### Since December 2004, the double floor rail has been standard equipment on the ATD II flush version.

## ATD II Rail

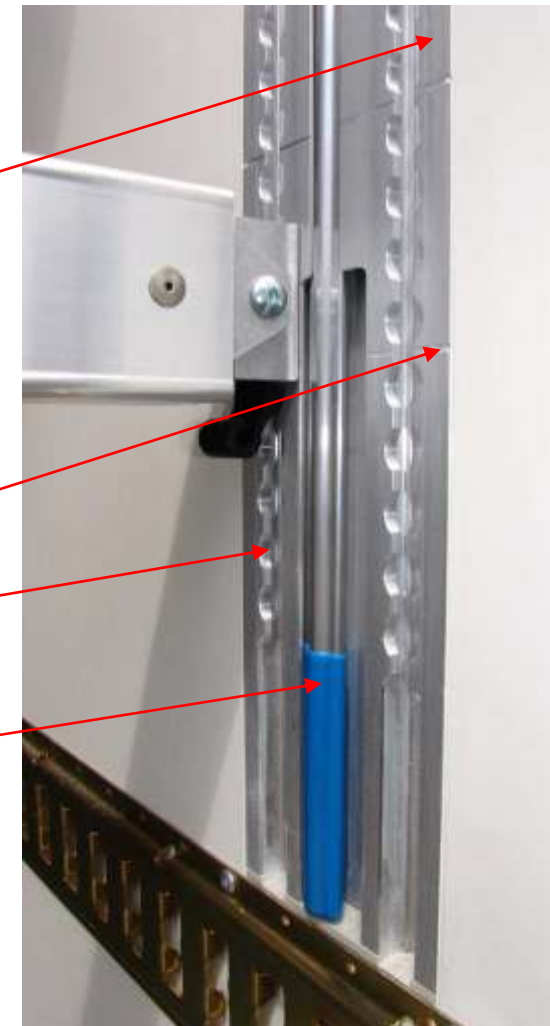
Previous versions (DP and DPA) have no longer been available since this date.

**Rail : Non-return** on the sides. (Flat railsurface with no catching points).

**Weight improvement** : 50 kg/rail DPA (90 kg/rail DP)

**Better insulation** (Reduced footprint).

**Visual markers** on the rails for **horizontal adjustment** of the beams.

**Adjustable beams** 25 by 25 mm.

**Locking rod incorporated** in the first rail.

**New beams** (Specific end fittings).

**Weight improvement** : 2 kg/beam (44 kg/semi)
